World Forum for Harmonization of Vehicle Regulations

Working Party on Noise

Report of the Working Party on Noise on its seventy-first session

Annex 3 – Appendix 2, amend to read:

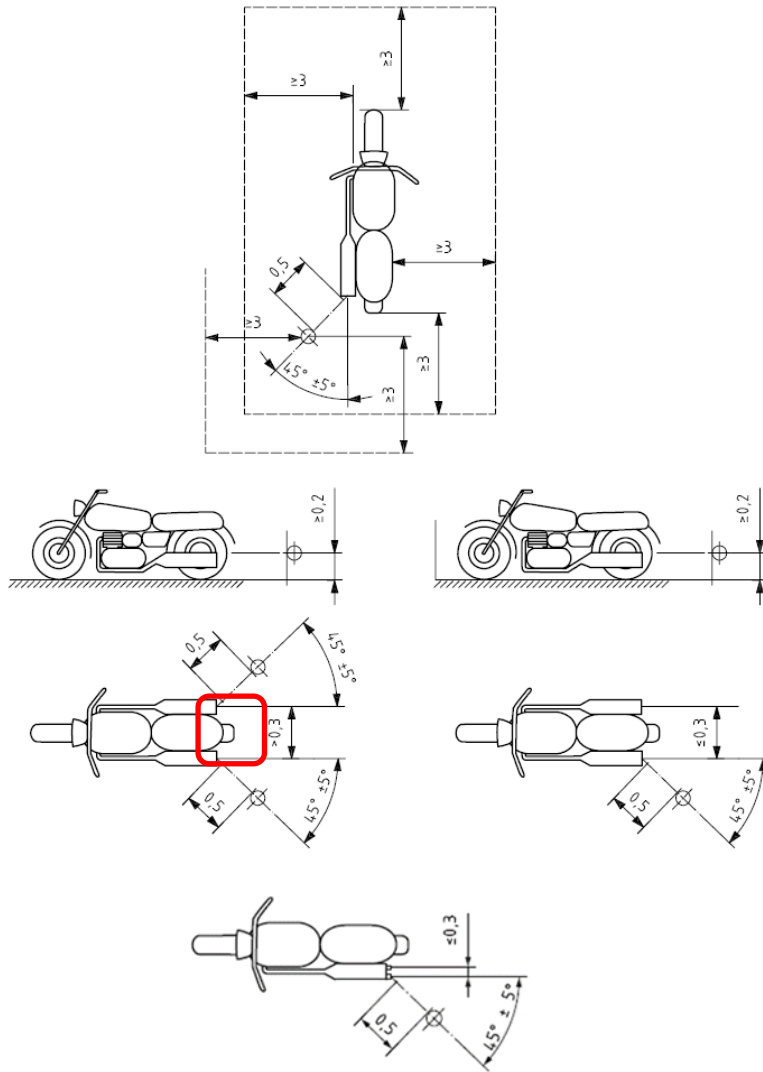
Annex 3, paragraph 2.4.1., amend to read:

If a vehicle has two or more exhaust outlets spaced less than **or equal to 0.3 m** apart and connected to a single silencer, only one measurement shall be made. The microphone shall be located relative to the outlet **furthest from the vehicle's longitudinal centreline**, or, when such outlet does not exist, to the outlet that is highest above the ground. **The 0.3 m measurement is to be made along a single plane perpendicular to the flow axis of the exhaust gases.**

If a vehicle has two or more exhaust outlets spaced less than or equal to 0.3 m apart and connected to separate silencers, only one measurement shall be made. The microphone shall be located relative to the outlet furthest from the vehicle's longitudinal centreline, or, when such outlet does not exist, to the outlet that is highest above the ground.

"Positioning of the microphones for the stationary noise test:
